**Yale Hydroelectric Project No. 2071 Entrainment Final Report
And
Bull Trout Entrainment Reduction Plan**

November 6, 2007

The Washington Department of Fish and Wildlife (WDFW) appreciates the opportunity to provide comments on PacifiCorp's Yale Hydroelectric Project Entrainment Final Report and Bull Trout Entrainment Reduction Plan *Working Draft*. – dated November 6, 2007.

Washington Department of Fish and Wildlife appreciates the opportunity to provide comments on PacifiCorp's Draft – ACC Review DRAFT Yale Hydroelectric Project Entrainment Final Report, May 1, 2007 (2007 Entrainment Report). First we will provide some general comments, followed by specific comments referencing page and paragraph.

Figure 5.4-3. Vertical distribution of all individual fish traces by their estimated total lengths within the entire acoustic beam for Yale Dam Turbine 1 (top) and Turbine 2 (bottom) from November 24, 2005 to July 19, 2006. The hatched line indicates the upper limit of the Fish Entrainment Zone.

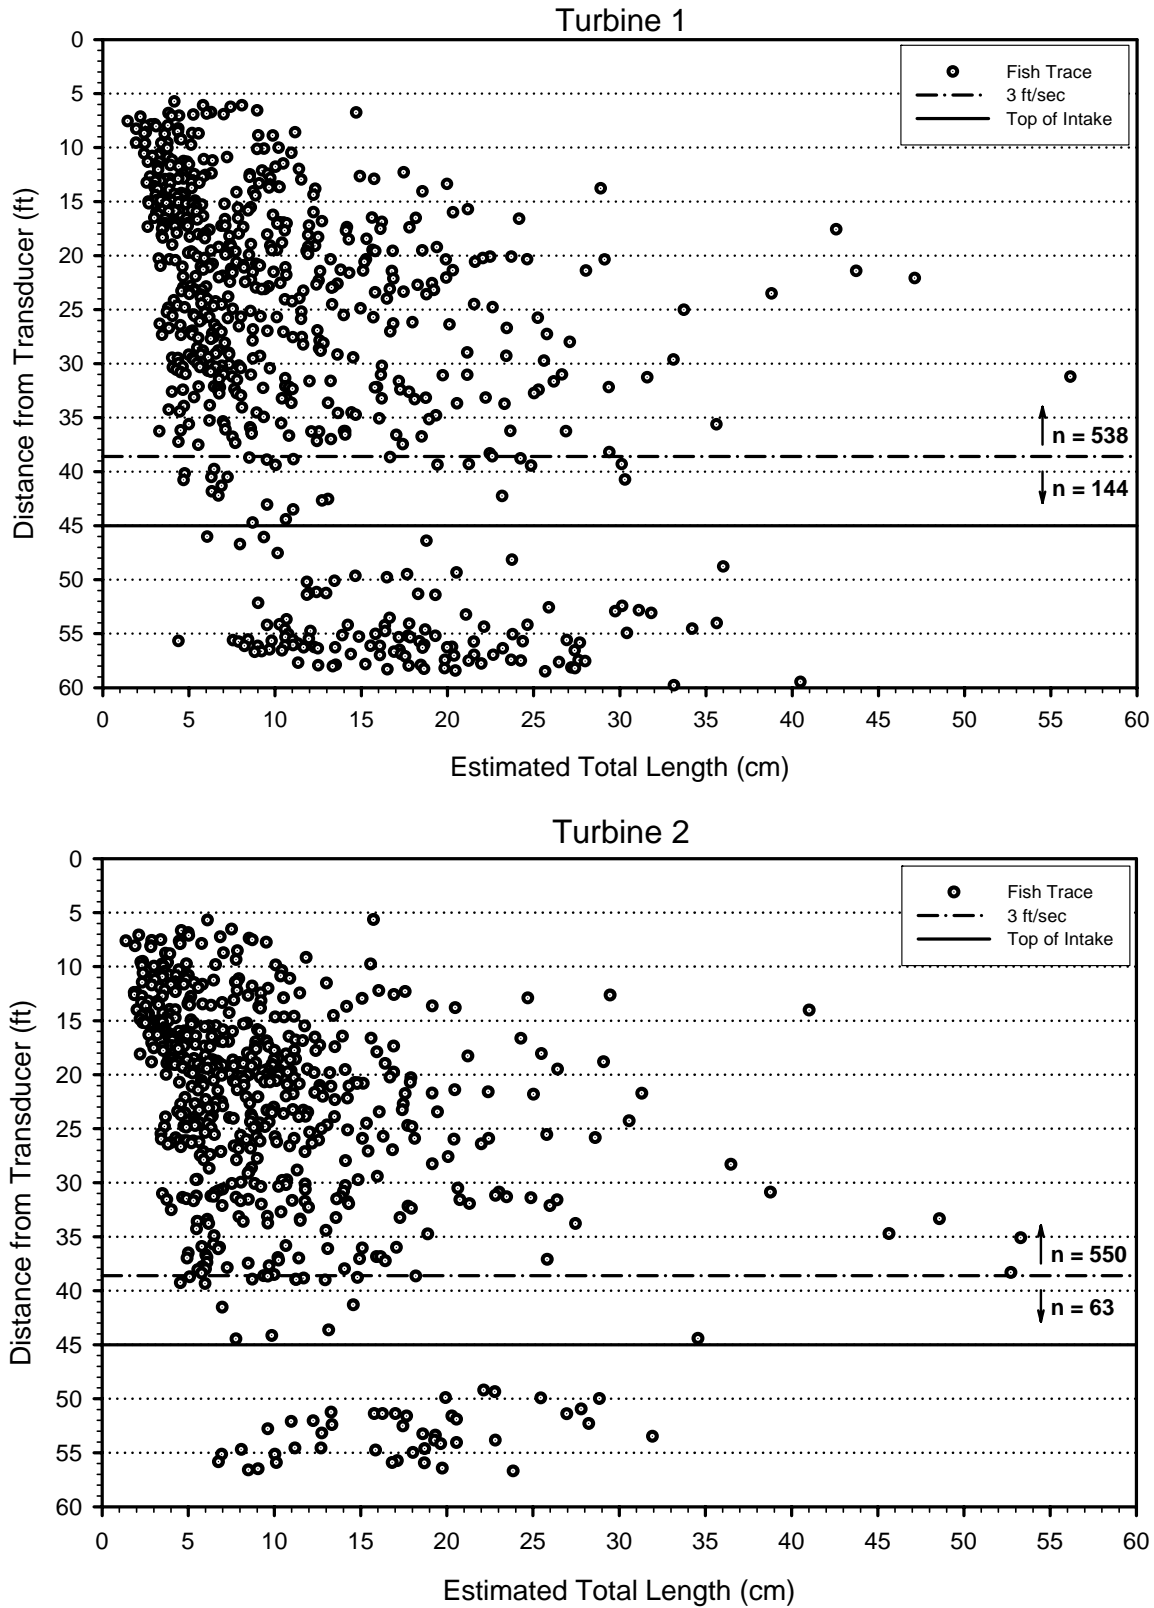
Page 26 Par. 2 A greater percentage of larger fish are at depth (Figure 5.4-3) within the entrainment zone. Migrating fish of this size have appeared in the Rush and Eagle Cliffs screw trap and in the Swift 1 entrainment screw trap. This indicates that a large number of fish the size of that bull trout are vulnerable to entrainment at Yale.

Figure 1. Estimated length-frequency distribution of entrained fish at the Yale Project (from PacifiCorp 2007)

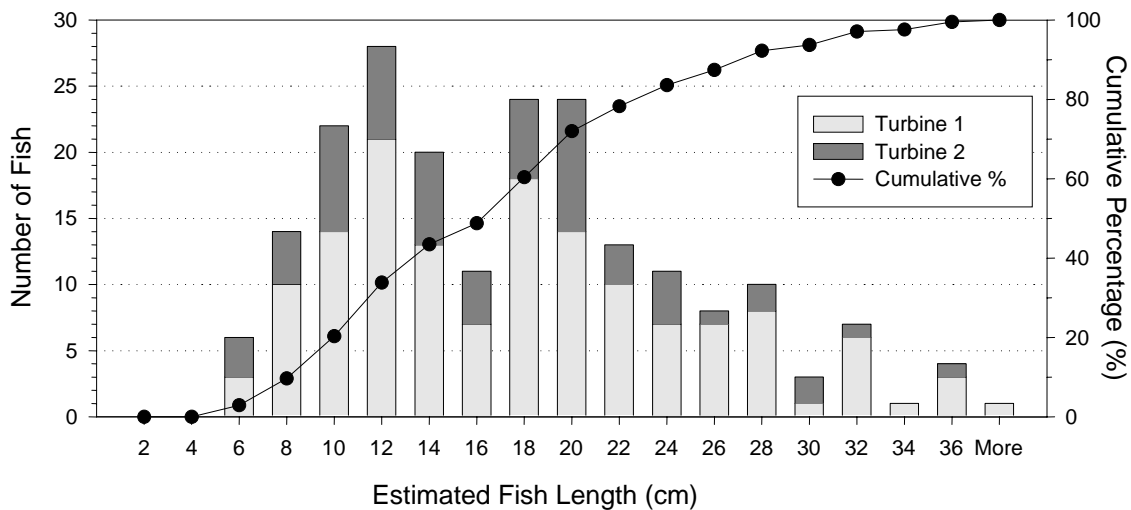
The mean size fish entrained in turbines 1 and 2 (Figure 1) correspond to fish captured in the Eagle Cliffs screw trap in 2001 (PacifiCorp, 2002). Page 3 of the working draft states: "However, given the low abundance of bull trout in Yale Lake and the observed length-frequency distribution of entrained fish, we expect that few adult bull trout were entrained during the entrainment evaluation." WDFW does not anticipate that adult bull trout are entrained. WDFW is not aware of any documented bull trout abundance estimate for Yale Lake, but we are aware of a series of yearly peak counts. WDFW's concern is that yearlings to three-year-old fish in the 80-240 mm size range are most likely to be entrained; and this fits the pattern of entrainment illustrated in Figure 1.

The mean size fish entrained in turbines 1 and 2 (Figure 1) correspond to fish captured in the Eagle Cliffs screw trap in 2001 (PacifiCorp, 2002). Page 3 of the working draft states: "However, given the low abundance of bull trout in Yale Lake and the observed length-frequency distribution of entrained fish, we expect that few adult bull trout were entrained during the entrainment evaluation." WDFW does not anticipate that adult bull trout are entrained. WDFW is not aware of any documented bull trout abundance estimate for Yale Lake, but we are aware of a series of yearly peak counts. WDFW's concern is that yearlings to three-year-old fish in the 80-240 mm size range are most likely to be entrained; and this fits the pattern of entrainment illustrated in Figure 1.
